Addenda No. 2

SUBJECT: OR7: Dewey Ave. UPRR U'xing (Baker City) Section
Whitney Highway
Baker County
Structure and Paving Project
(Bids to be opened and read April 30, 2009)

OR7: Dewey Ave. UPRR U'xing (Baker City) Section
 Whitney Highway
 Baker County
 Structure and Paving Project
 (Bids to be opened and read April 30, 2009)

TYPICAL SECTIONS

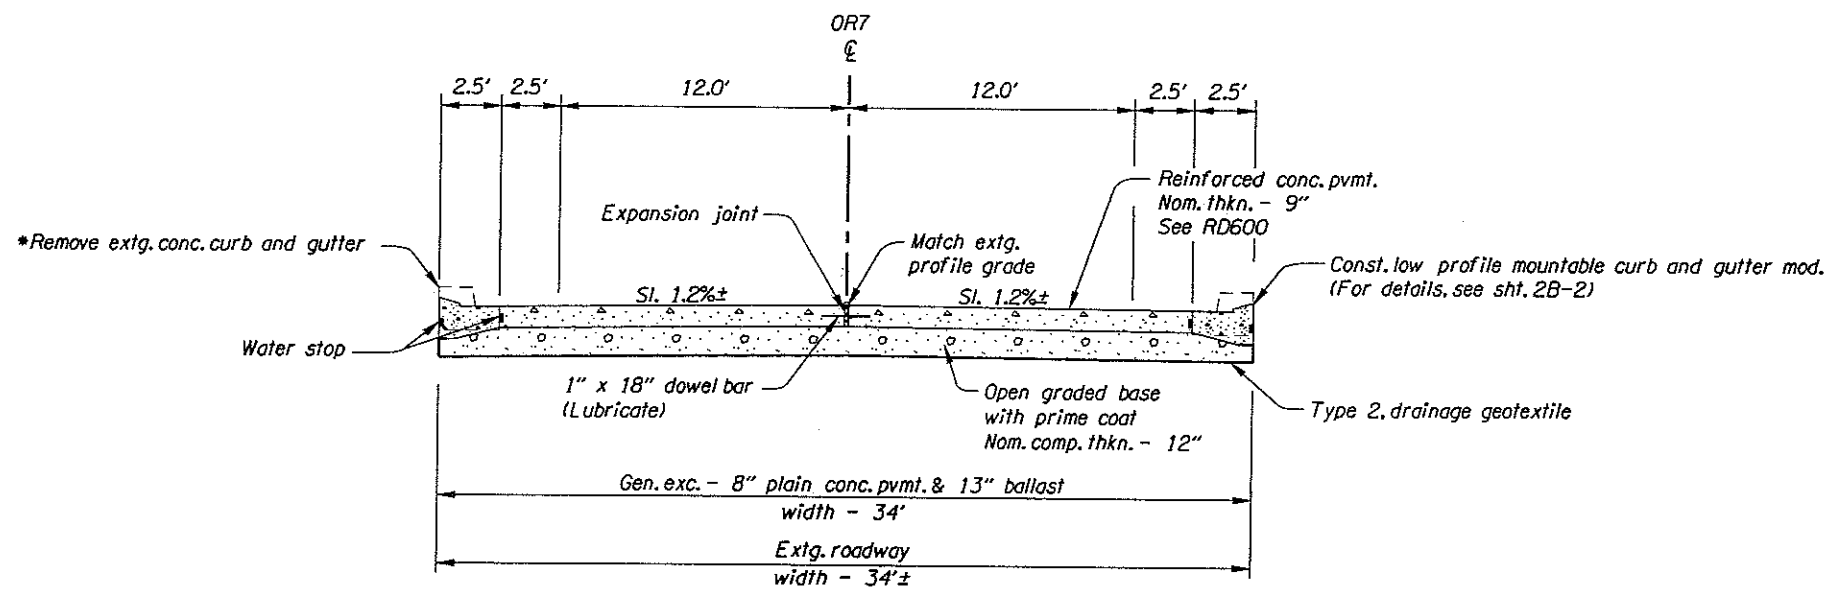
1	Revised 04-17-09 Revised stone embankment
2	Revised 04-17-09 Added rock mulch
3	Revised 04-17-09 Added dimensions

SHEET NO. 2

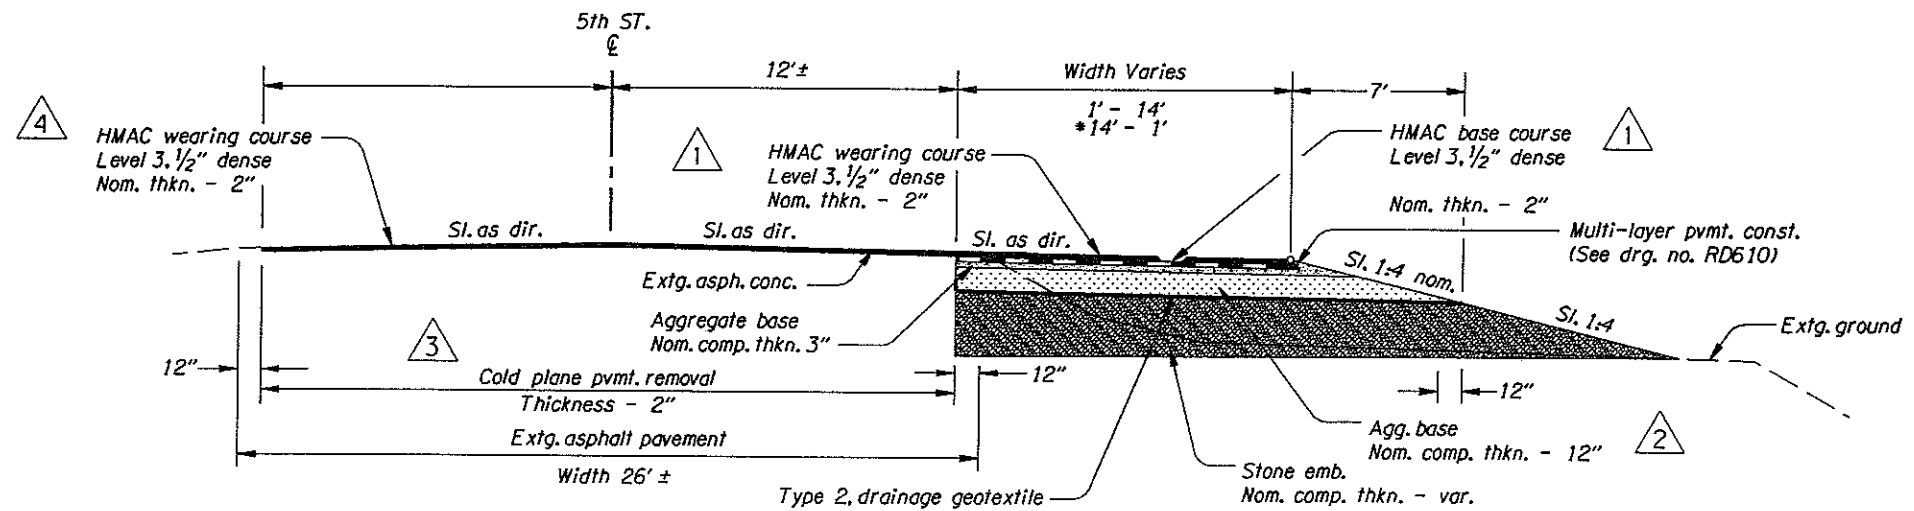
1	Revised 04-17-09 Revised HMAC
2	Revised 04-17-09 Change label to agg. base
3	Revised 04-17-09 Added cold plane pvmt. removal
4	Revised 04-17-09 Added HMAC

SHEET NO.
2B-2

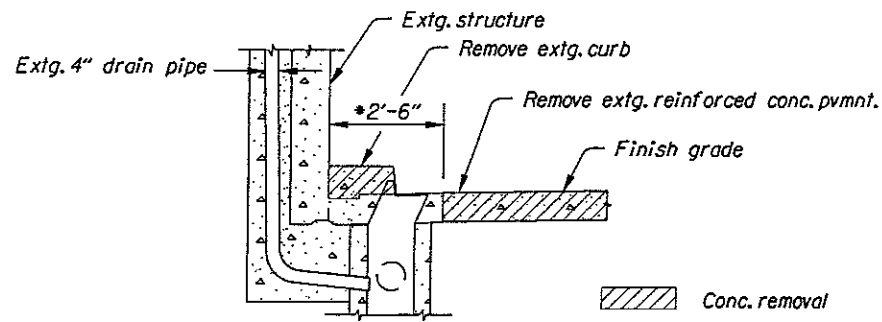
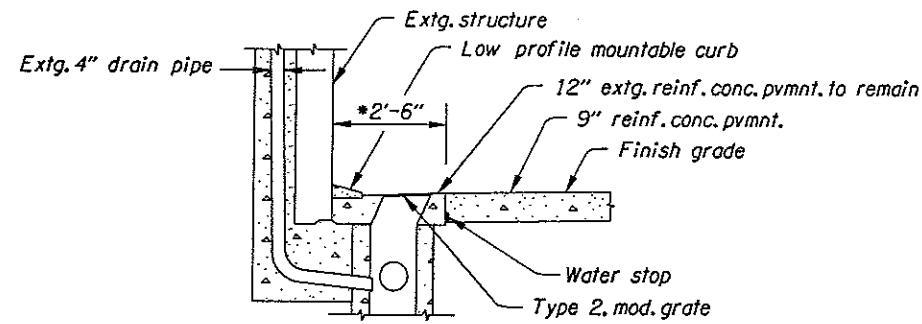
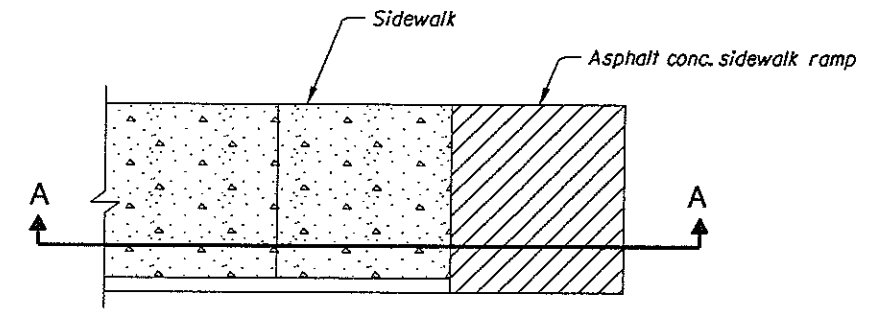
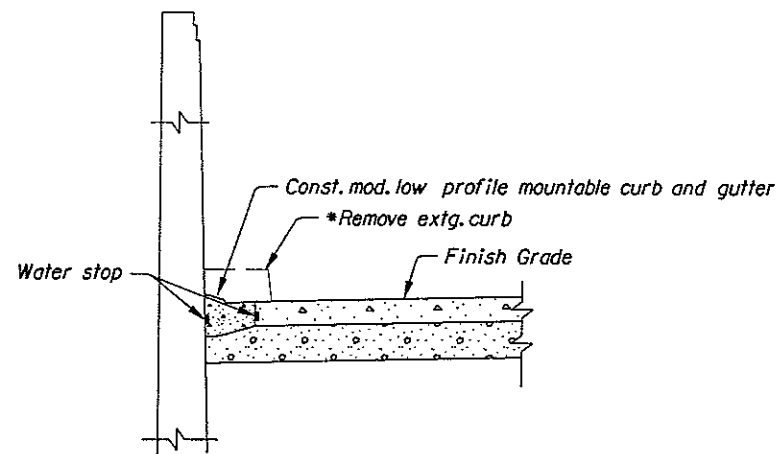
1	Revised 04-17-09 Added removal details
2	Revised 04-17-09 Added curb details

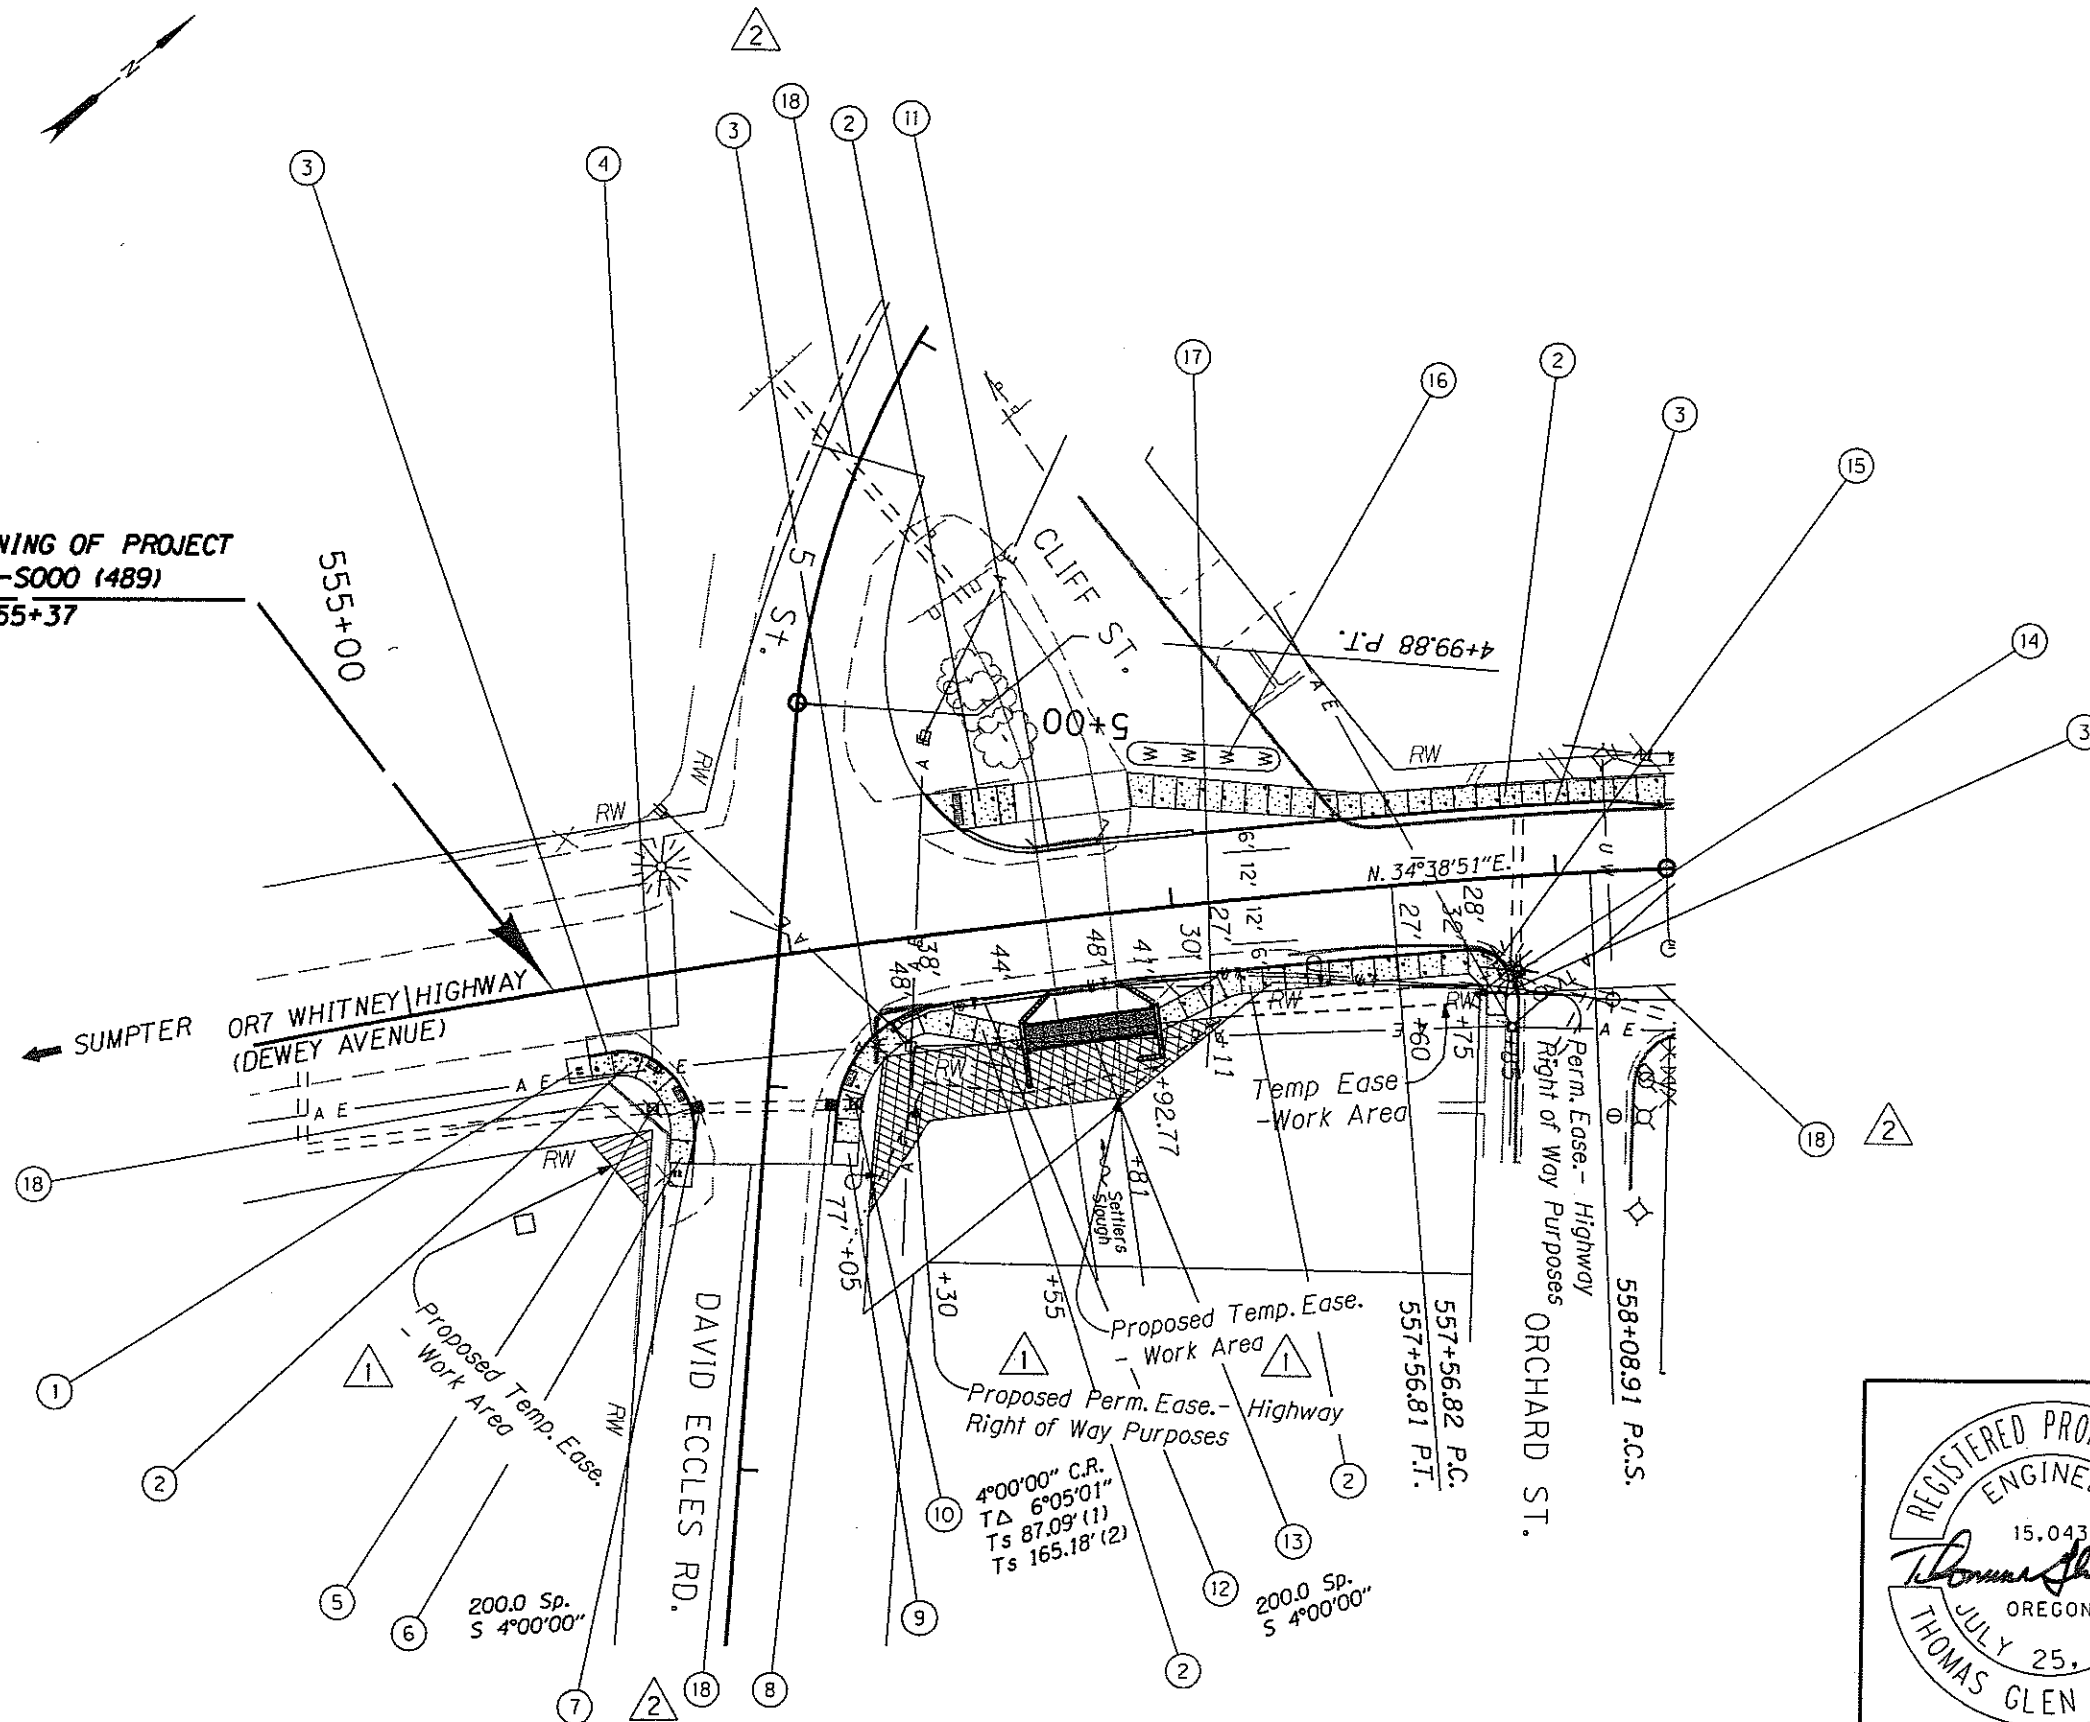
△ 1	Revised 04-17-09 Proposed Right of Way
△ 2	Revised 04-17-09 Added Street Conn. Notes

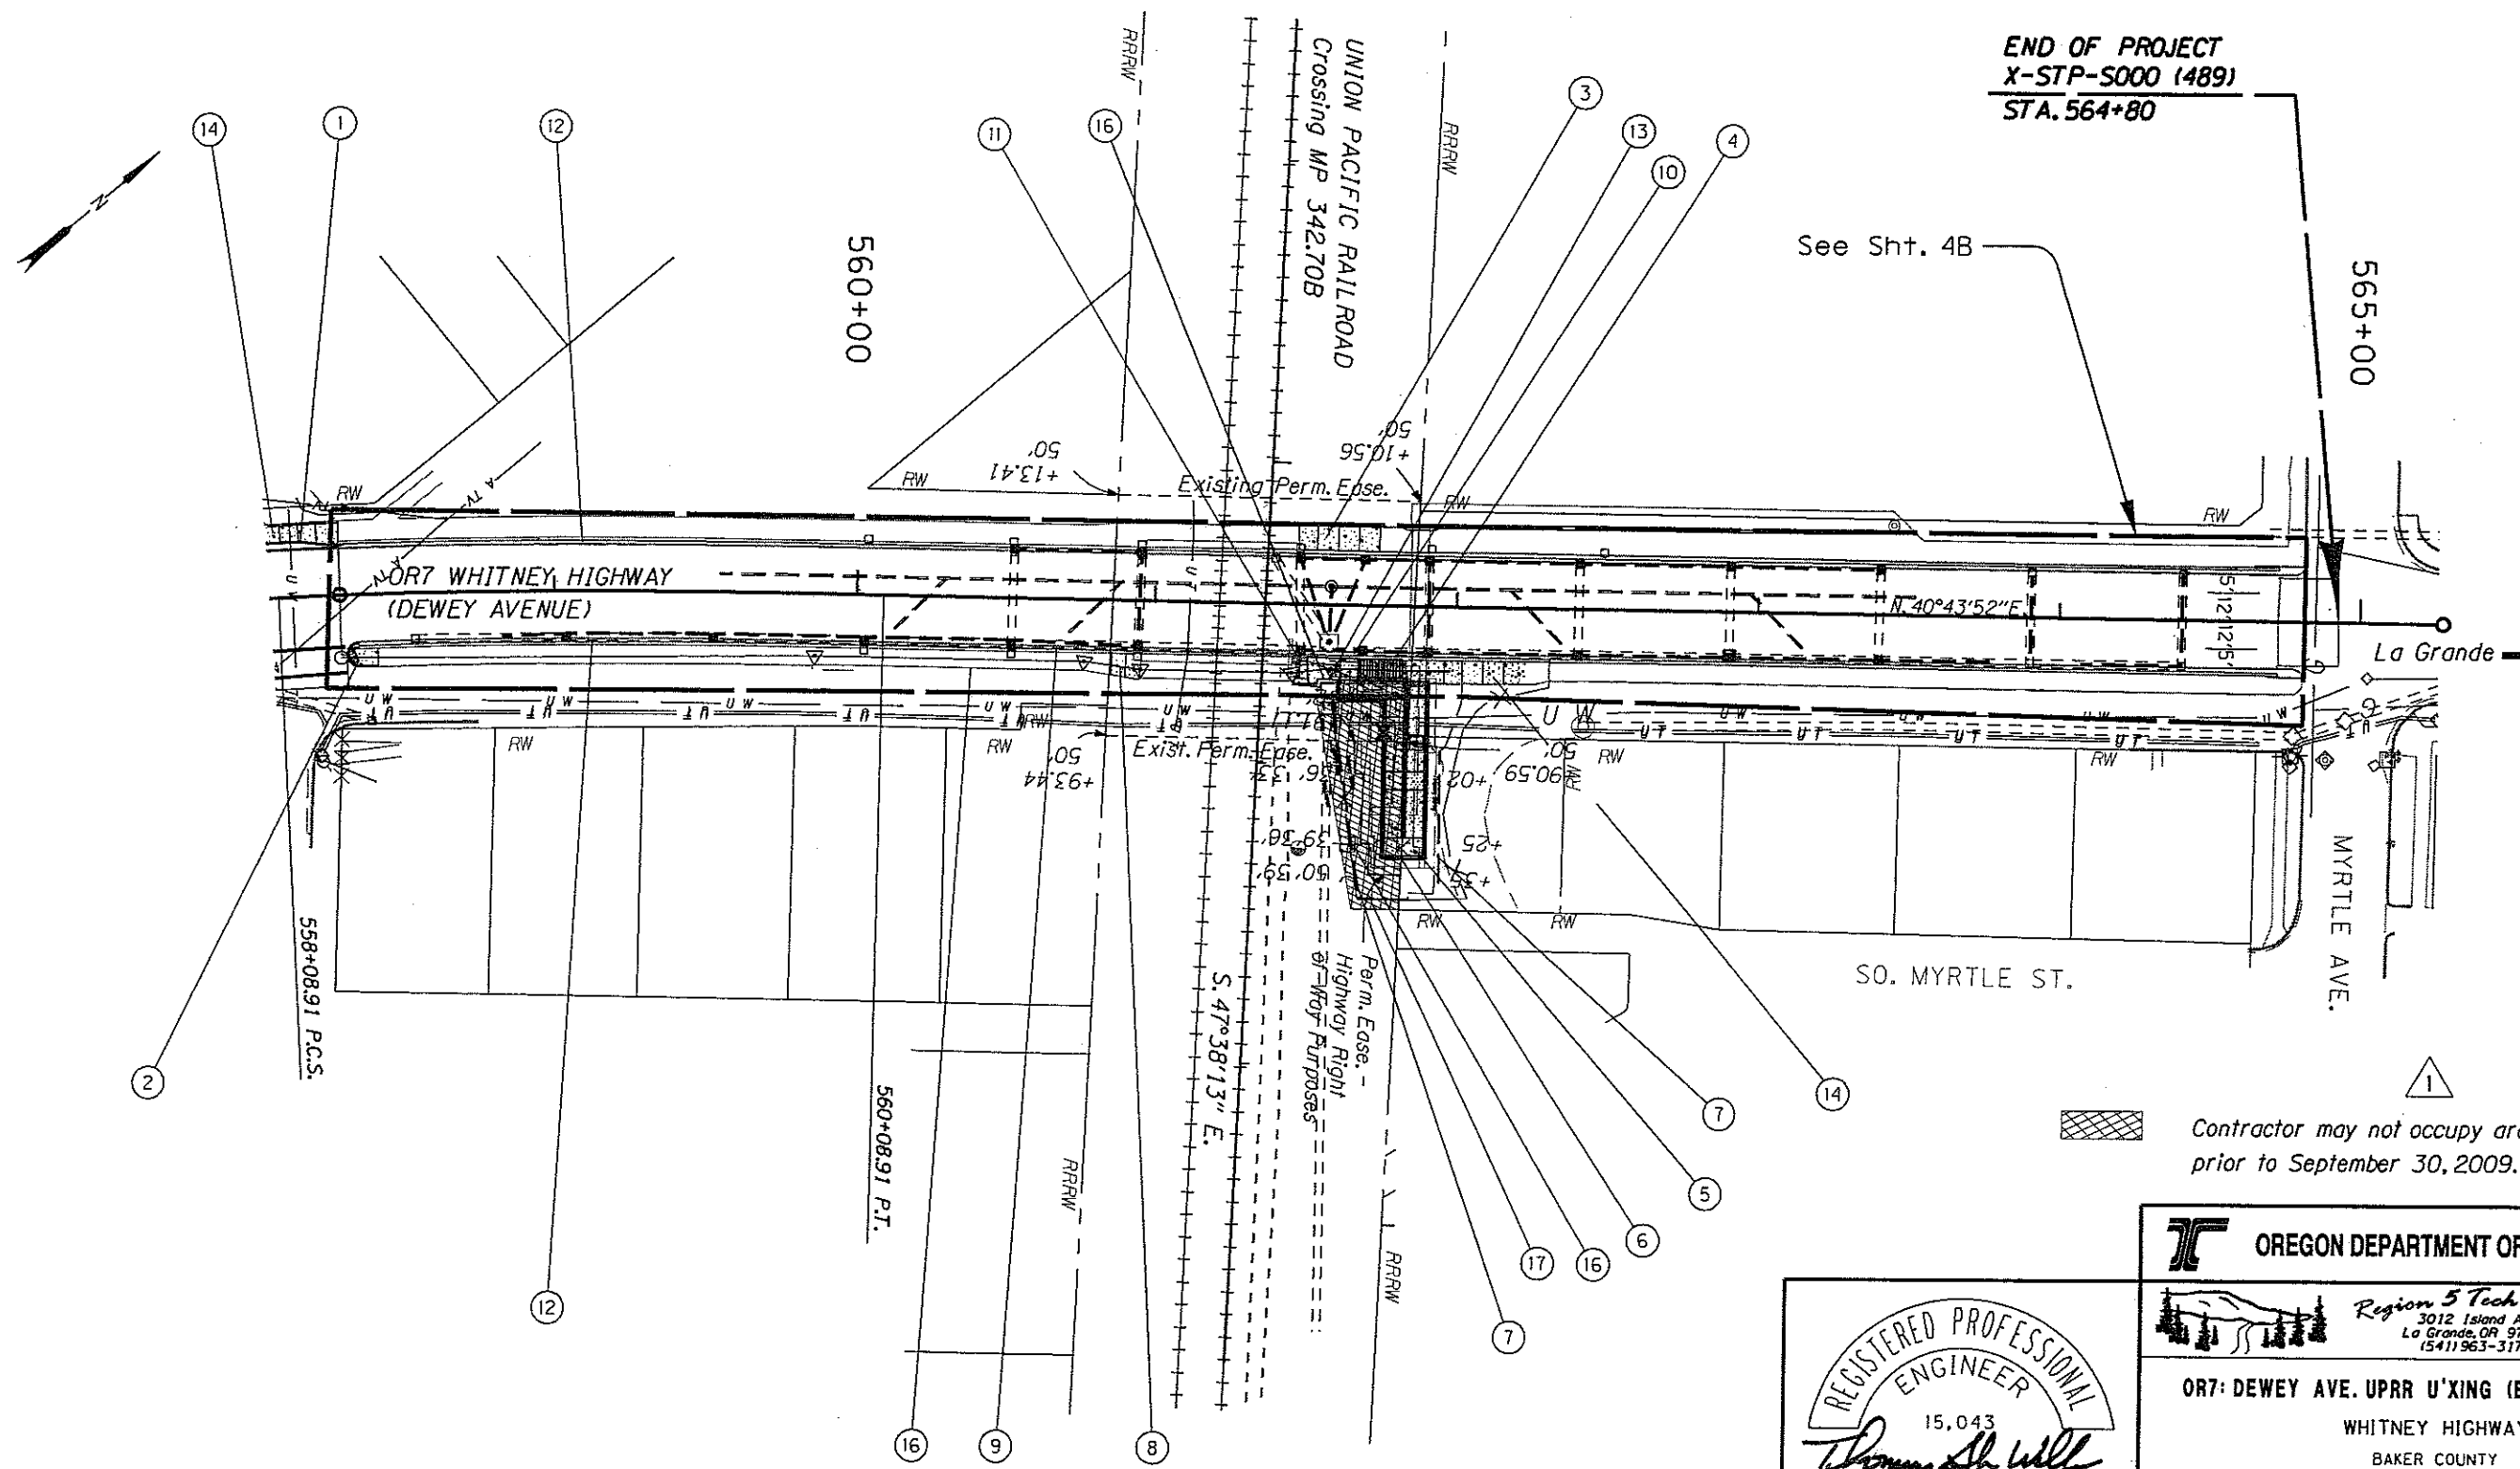
1	Revised 04-17-09 Revised Right of Way Holdout Note
---	---
